Memorandum

Re: Re-submittal of Site Plan-DFT _ PR-2024-010784/SI-2024-01164

The following memo provides responses to DFT staff comments for the SOMOS Affordable Housing Plan, Site Plan-Administrative application heard on August 21, 2024. Staff comments are in italic followed by the Applicant responses.

LANDSCAPE
PLAN

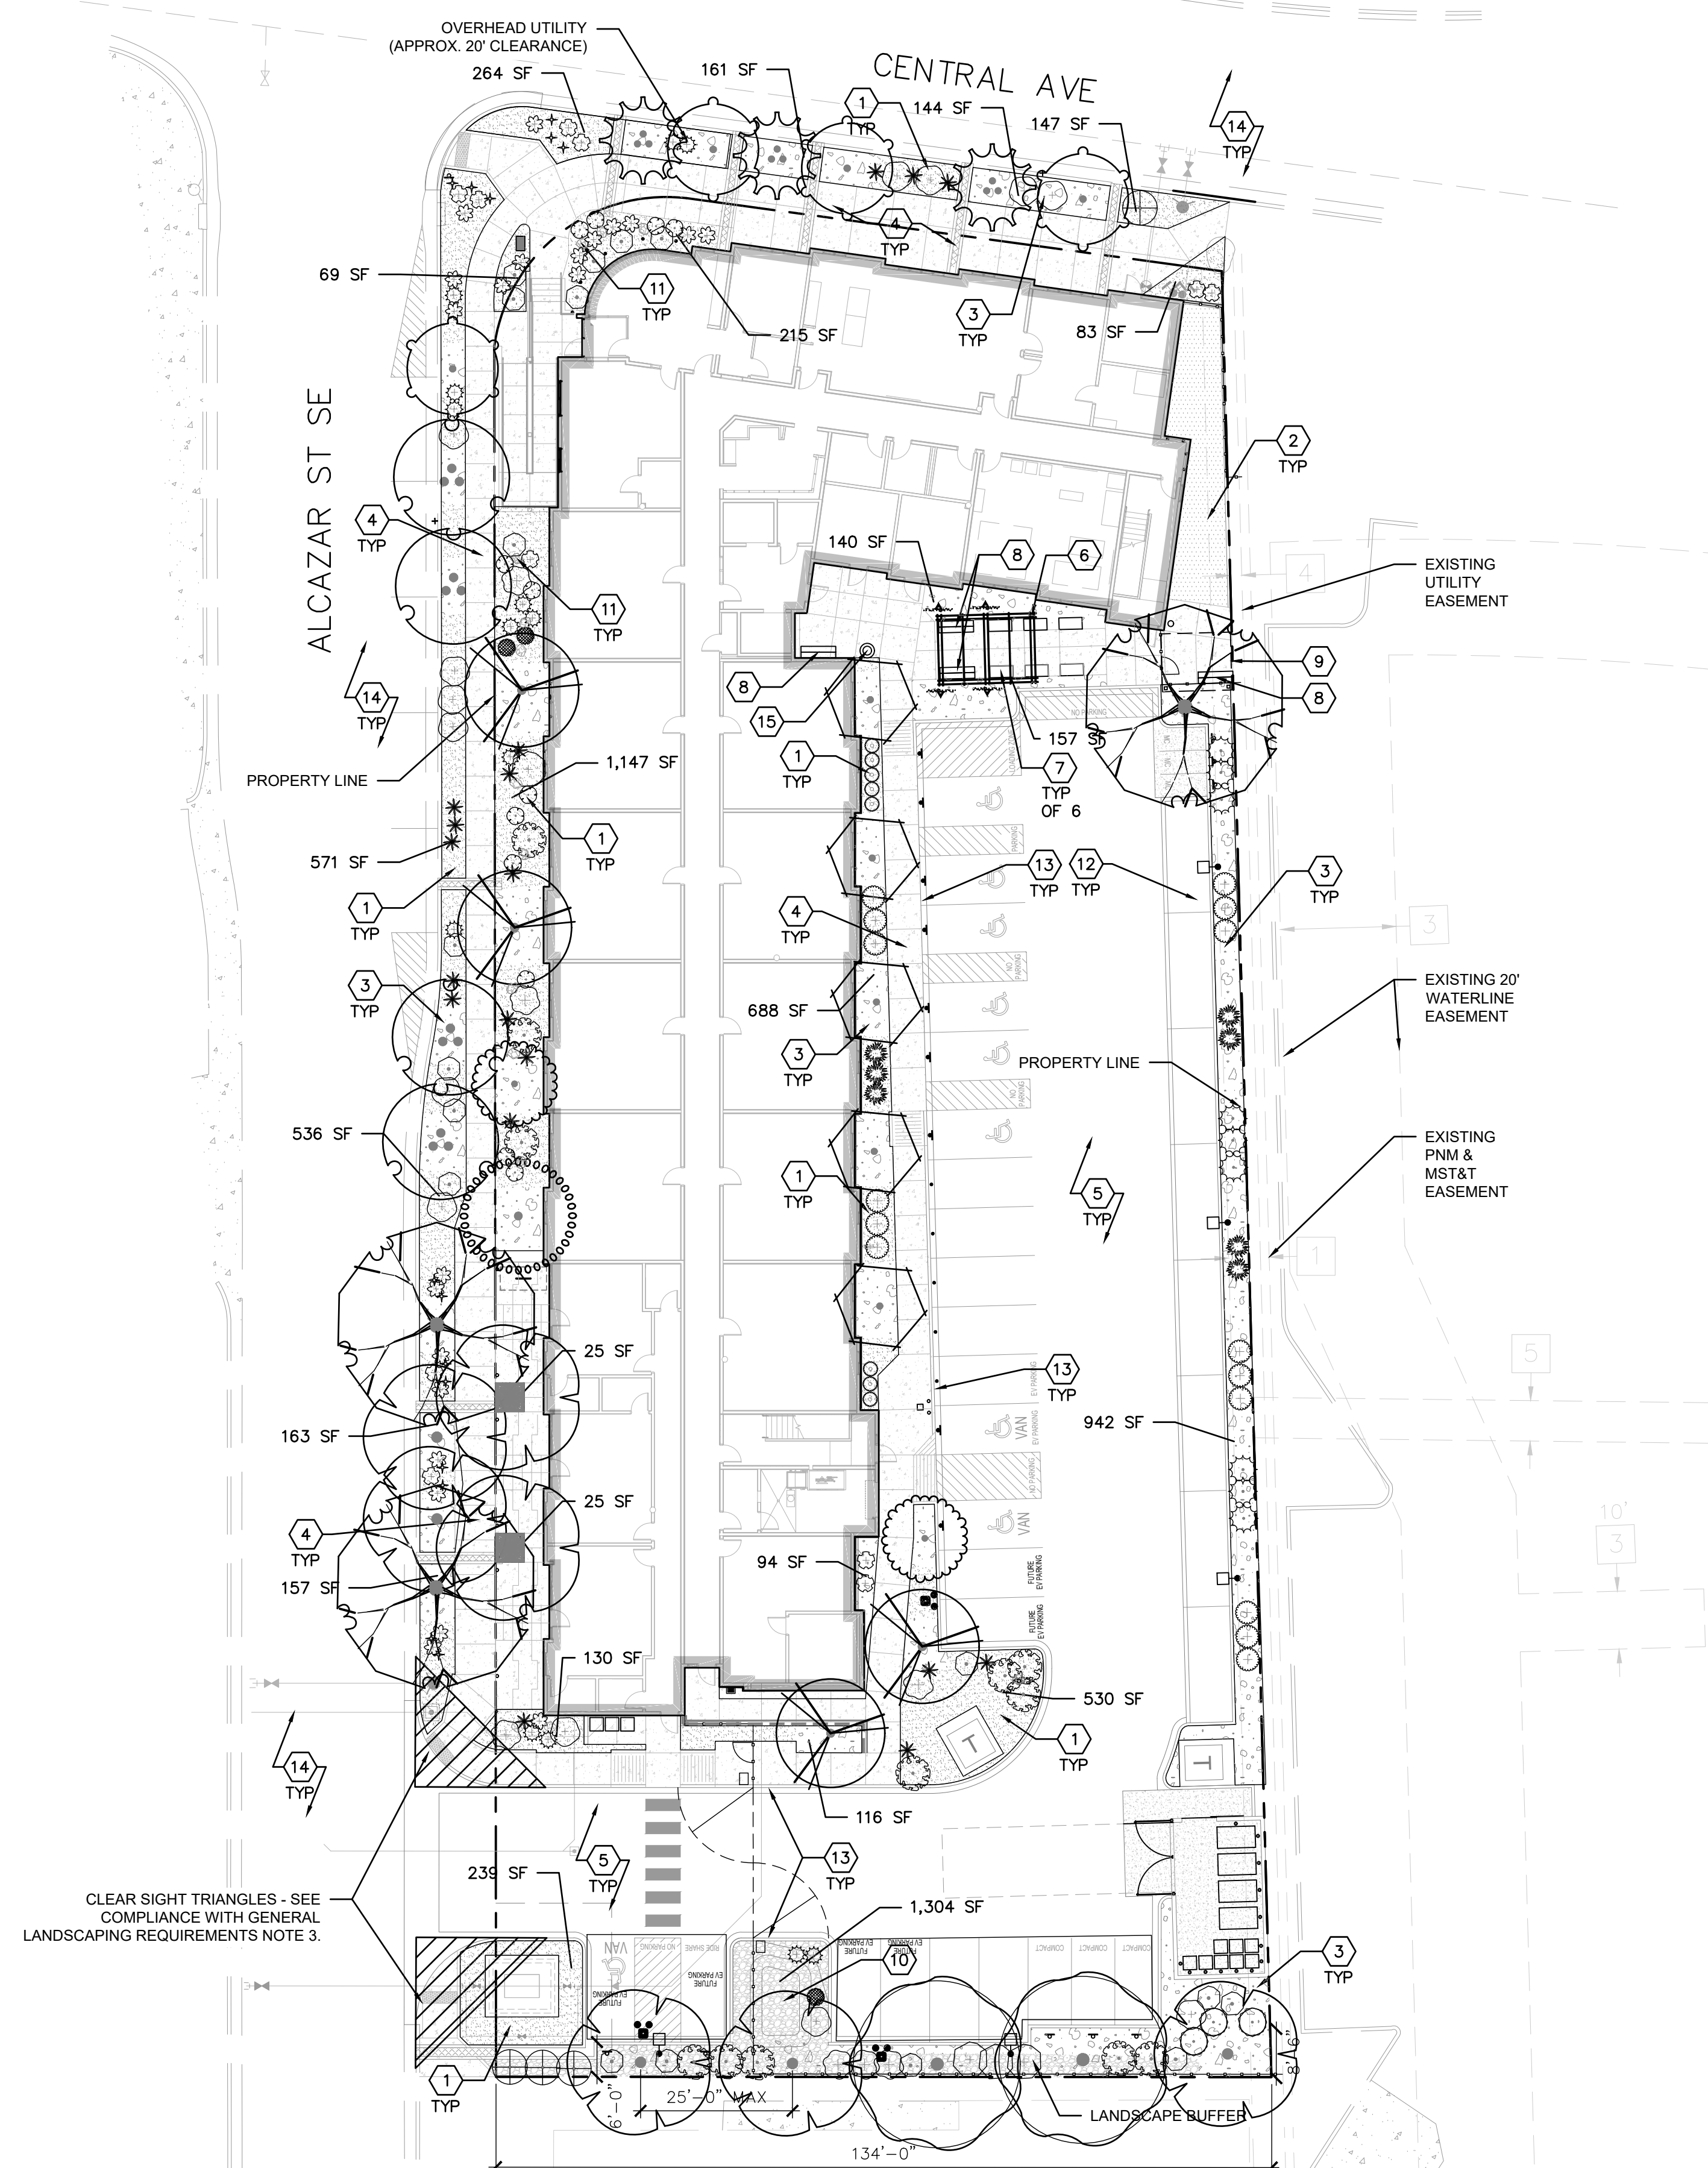
*Per 5-6(C)(10)(d), if overhead distribution electric lines are present and large trees cannot be planted due to potential interferences with the electric lines, one ornamental tree with a mature height of 12 feet shall be planted per 20 feet of street frontage. New trees planted near electric transmission lines shall be no taller than 25 feet in height at maturity to avoid conflicts with existing electric facilities. **Consider alternating the trees in this area to avoid loss of all trees due to potential future disease. Pink Pom Poms redbud, Paul's Scarlet Hawthorne, and Goldenrain tree are suggested by the City Forester for these areas.***

*Per 5-6(C)(10)(f), trees shall not be planted near existing or proposed street light poles. 15 feet of clearance is required. **Please confirm compliance with this code.***

Applicant Response: Compliant. Revised Landscape Plan includes Pink Pom-Pom Redbud along Central Avenue.

Applicant Response: Compliant. Revised locations shown on Landscape Plan.

BUILDING ELEVATIONS -
DFT SUBMITTAL
SHEET NUMBER

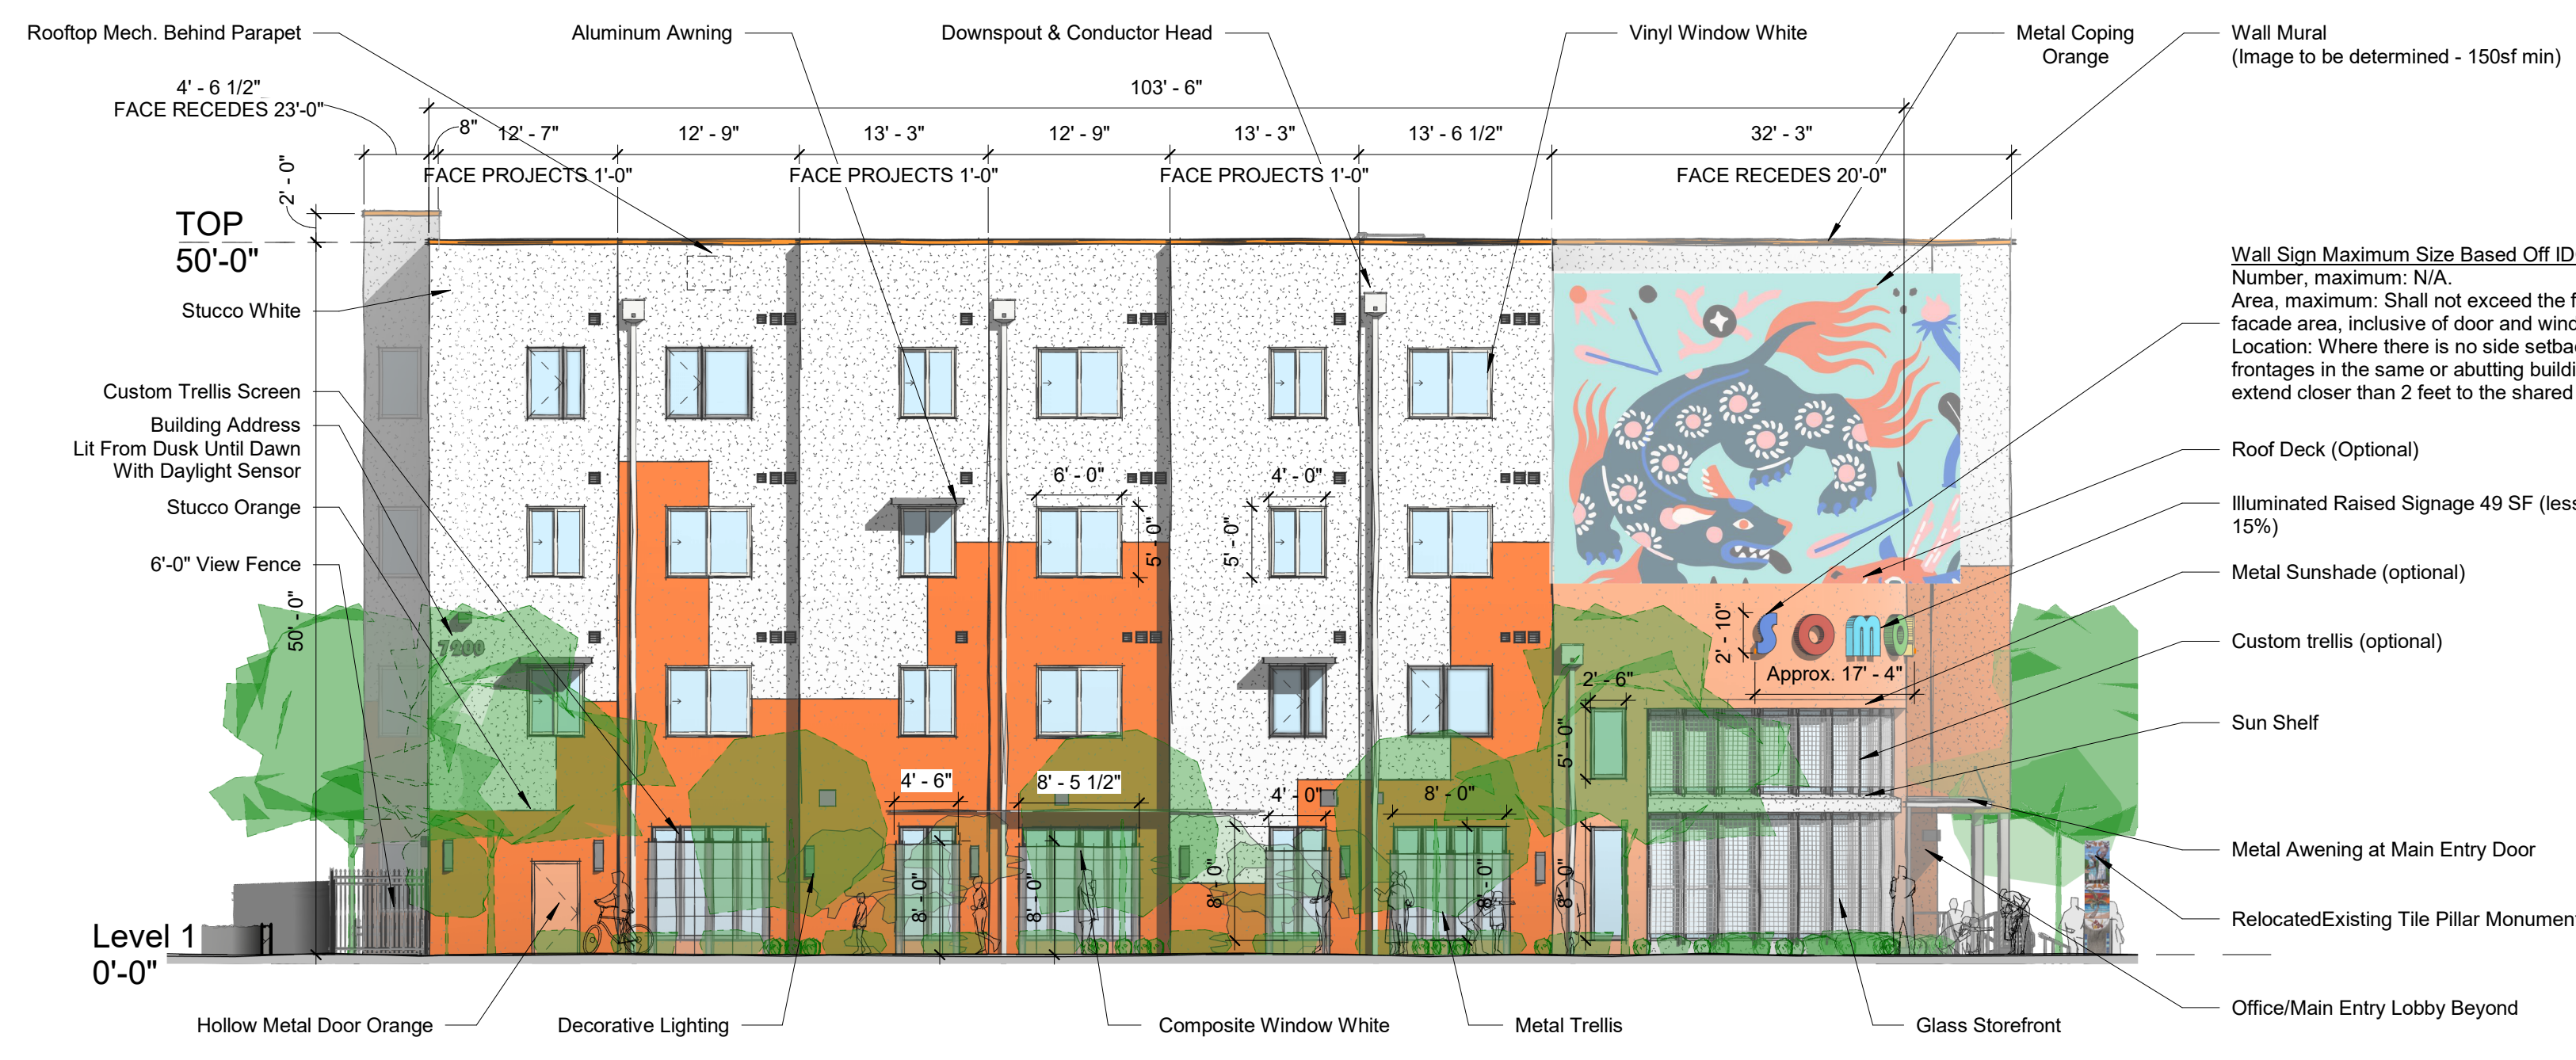
For heat mitigation along west-facing facade, more awnings are required especially for the second and third floors.

Applicant Response: Aluminum awnings over bedroom windows were added to the fourth floor, maintaining the rhythm of the awnings on the lower floors (see Elevation Sheet SP-8).

D5 REFUSE ENCLOSURE SOUTH
1/4" = 1'-0"

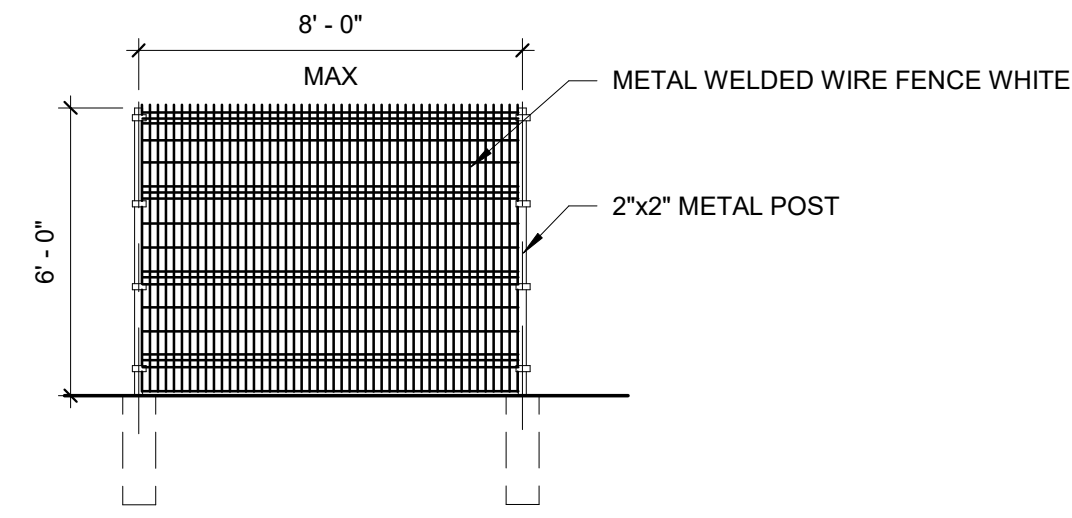
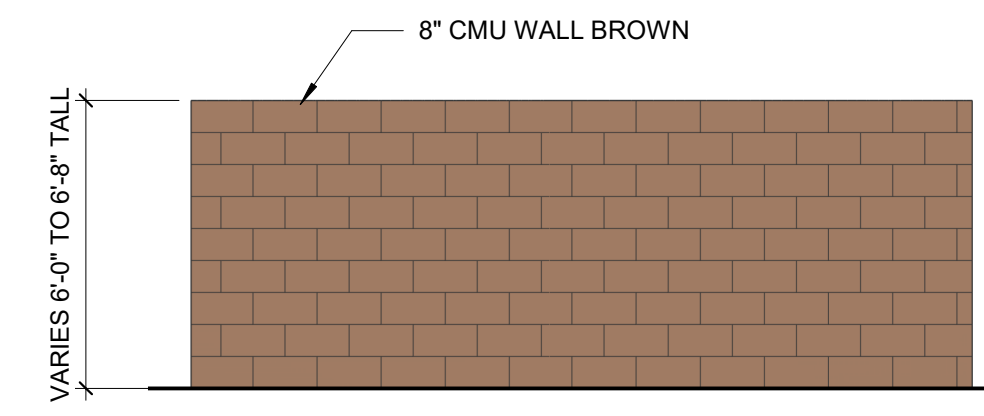
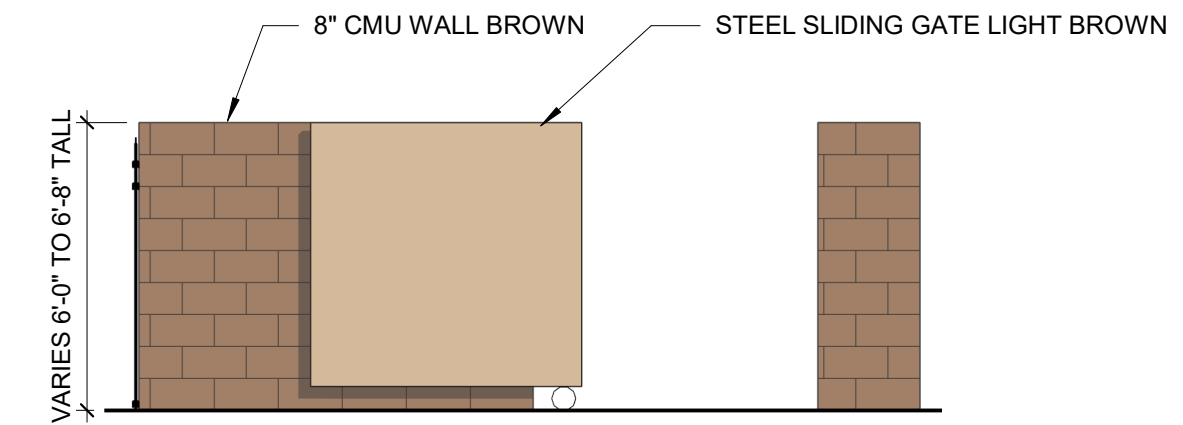
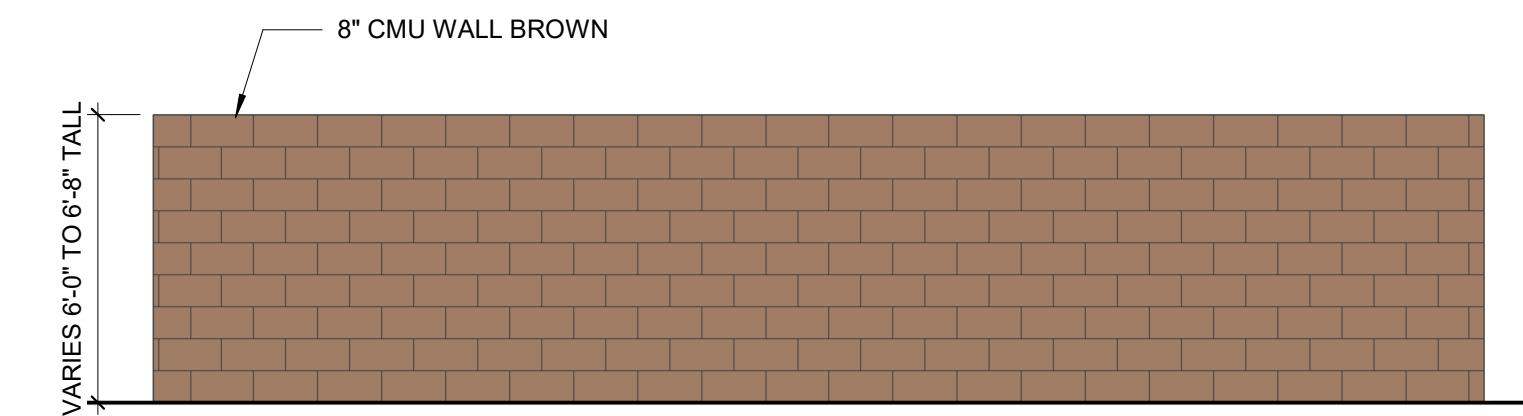
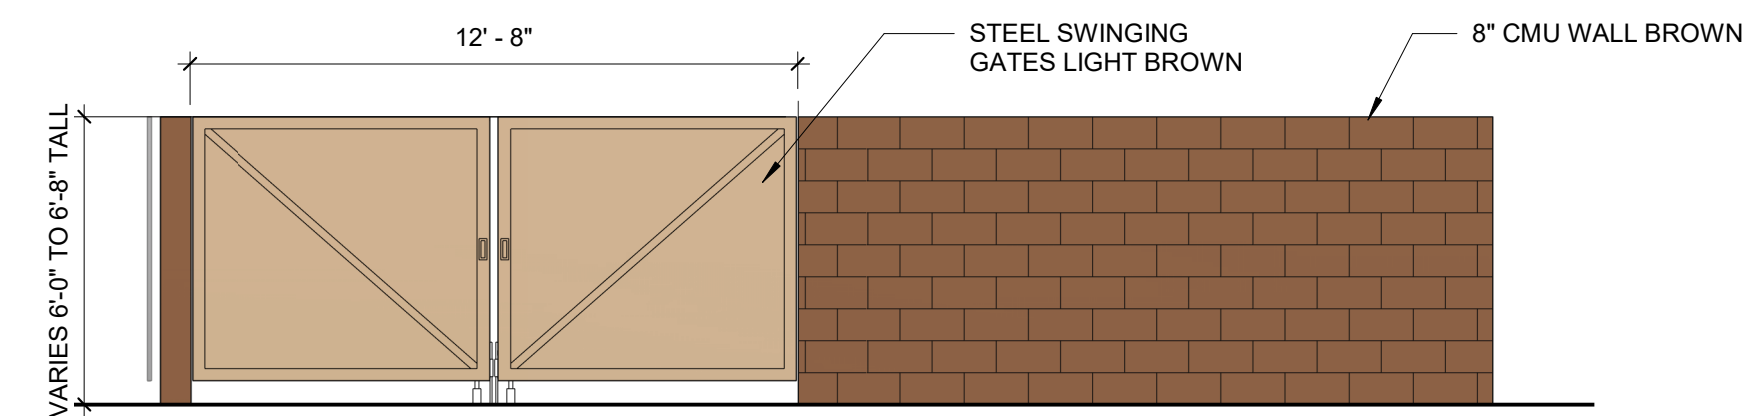
*Per 5-6(G)(3)(a) Covering Waste Containers, all waste containers and dumpsters shall be in a roofed enclosure or be equipped with and use a lid covering and shall be designed so that stormwater runoff does not reach storm drain inlets. *Confirm compliance**

Applicant Response: Compliant, refuse containers are roll-out bins with lids. Details for refuse containers are provided on Sheet SP3.
